## BRISTOL AIRPORT

### Development of Bristol Airport to Accommodate 12 Million Passengers per Annum.

### Additional Information for Natural England

Figure 1. Bristol Airport Woodland/Proposed SPD/SAC Replacement Habitat and Tree/Crop Boundaries

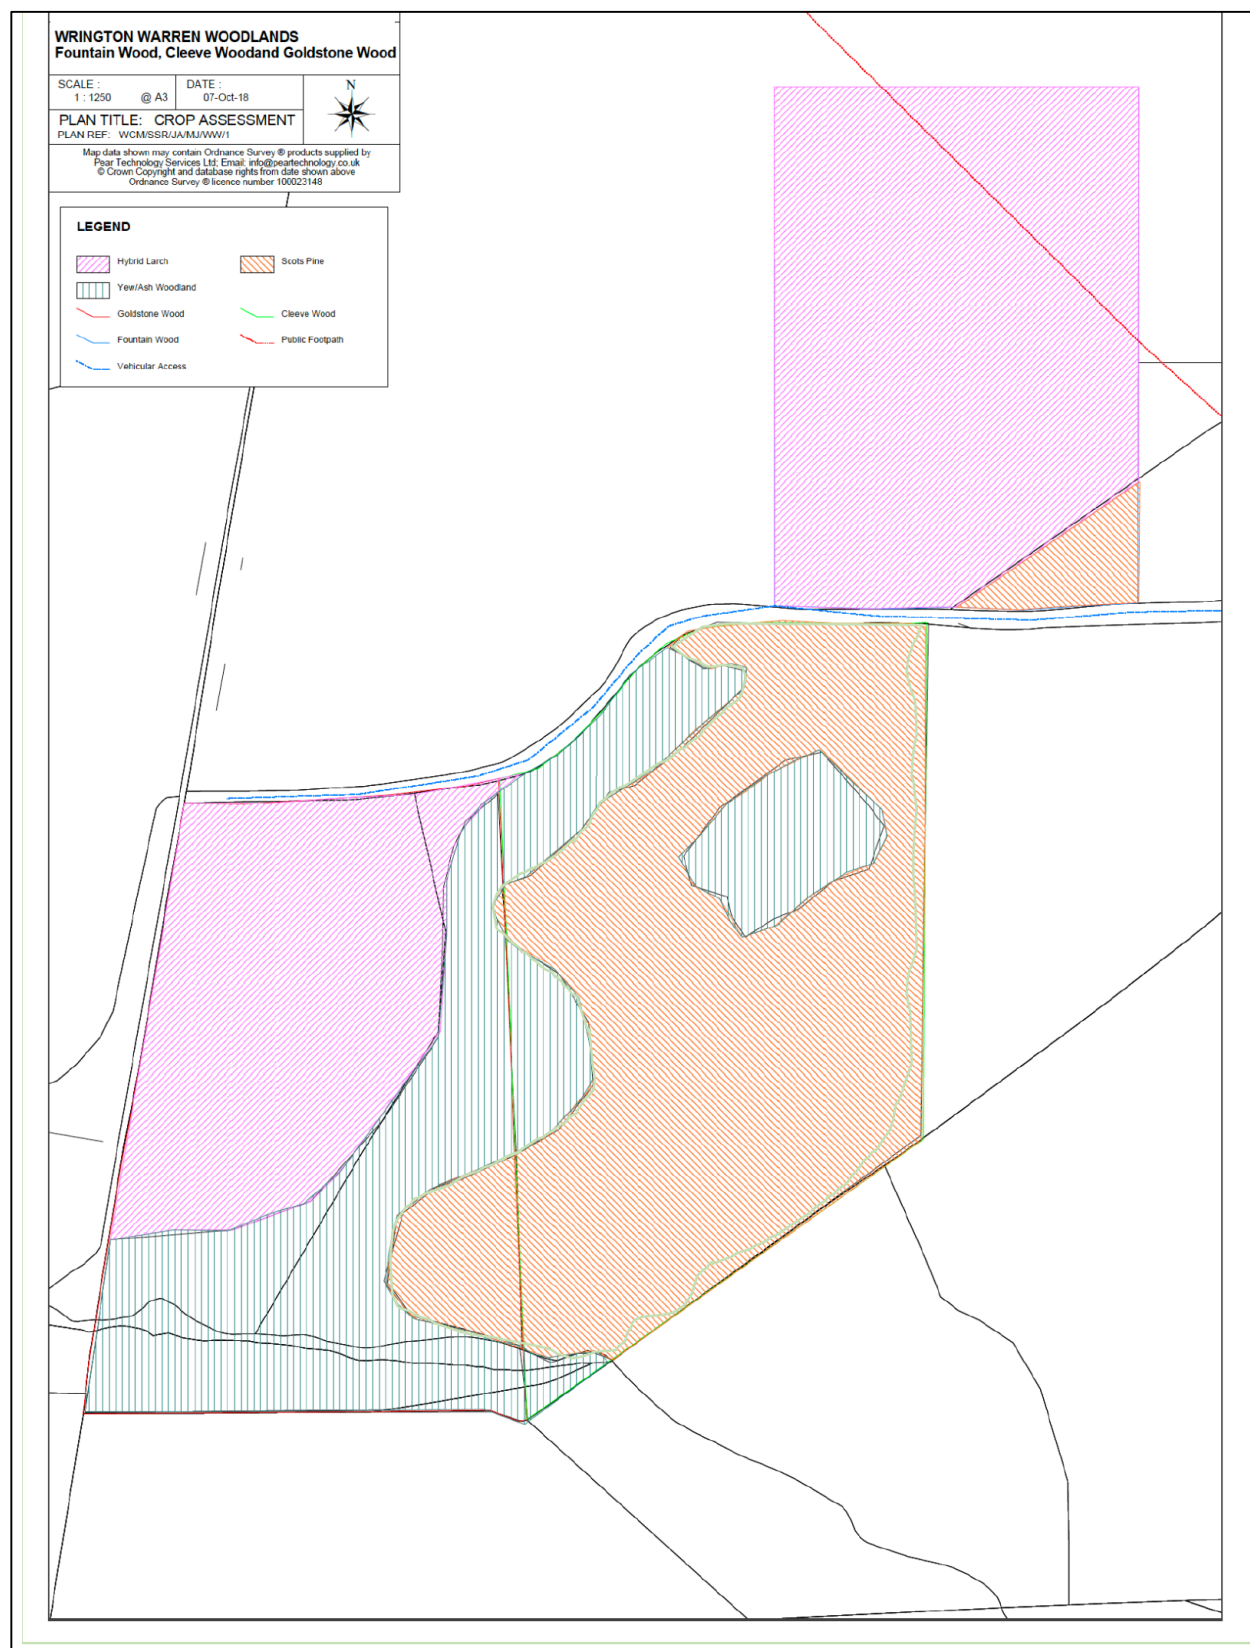
- 2.1.2 NE: According to our GIS records, FC's National Forest Inventory describes the woodland as 'conifer'; however although conifer is present in parts of the woodland, other tree species and a degree of understorey are also present. A map showing the % of conifer/broadleaf and ideally tree species is needed to determine more accurately its existing habitat value to HS bats.  
JA: As part of the investigations conducted by Bristol Airport and Johns Associates, a formal woodland survey and inventory of tree species, coverage and standing crop of timber was completed

2.1.3 JA: Our field survey of the Bristol Airport owned woodland, completed in 2018 by a suitably experienced specialist, confirms the following areas associated with different tree species:

Grand total area of 6.24ha woodland, within much larger connected woodland/forestry area.

Goldstone Wood (2.18ha total): 1.06ha hybrid larch in the north west, 0.17ha of Scot's pine in the south east. Remainder of 0.95ha of yew and mixed native broadleaved associated with the quarrying. **Total of 1.23ha suitable replacement habitat.**

Cleeve Wood (2.29ha): 1.88ha of Scots Pine (with a scattering of mature native broadleaves (ash and oak within the canopy and sycamore and holly in the understorey), with 0.51ha with Yew and native mixed broadleaved. **Total of 1.88ha suitable replacement habitat.**

Fountain Wood (1.77ha): 1.64ha of hybrid larch, 0.11 of Scot's Pine, 0.02ha footpath. **Total of 1.75ha suitable replacement habitat.**

2018 SPD calculations required 4.38ha. The BRS woodland provides 4.86ha of suitable replacement habitat outside of the boundary associated with Goblin Coombe SSSI, based on removal of conifers only to achieve 20% canopy coverage within this area (representing 77.4% of BRS woodland), leaving 22.6% non-modified.

Please refer to Figure 1 provided overleaf.

Figure 2. Draft outline management approach

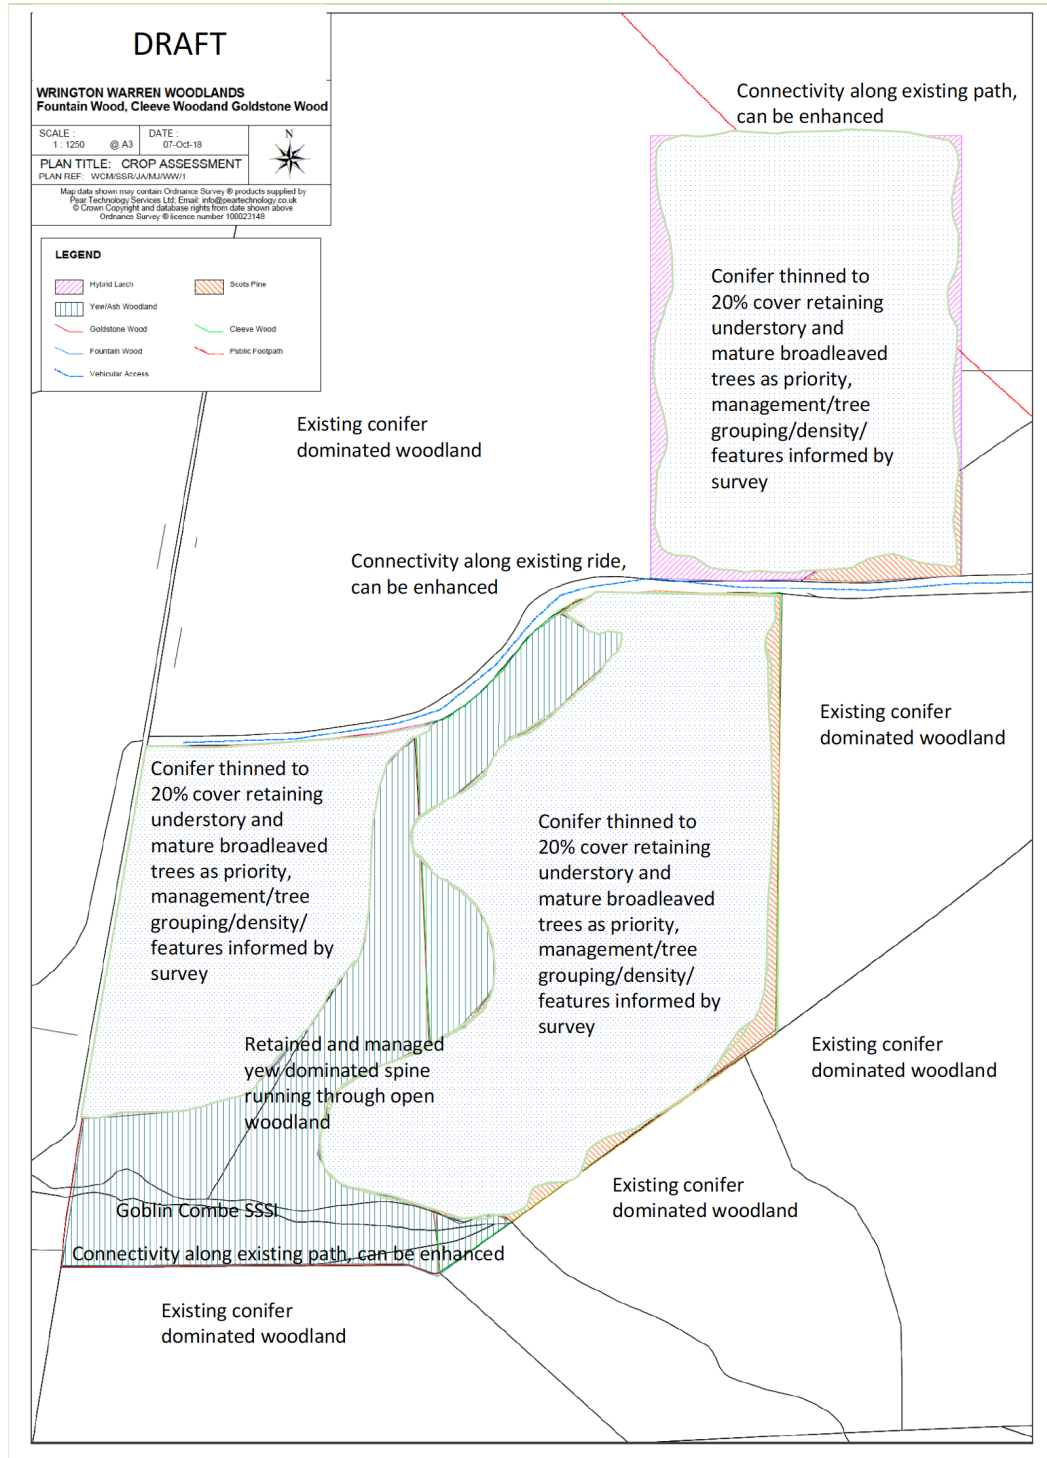
*A6.4 Again off-site the replacement of coniferous woodland with broad-leaved woodland would benefit Greater Horseshoe bats. This should be carried out gradually over a period of time to avoid extensive clear-felling.*

JA: The proposals are not clear felling, rather a reduction in canopy cover to 20% in some circa 75% of the woodland area with circa 25% being retained in a more dense/existing form. Subject to approval, we do propose to undertake this reduction in canopy as a single carefully implemented activity (e.g. over a few months) to bring about the habitat enhancement benefits quickly, prior to any existing habitat loss, noting the significant expanse of adjoining retained 3<sup>rd</sup> party woodland. Please

refer to a basic draft plan of areas proposed to be reduced in canopy density and those retained in Figure 2 below).
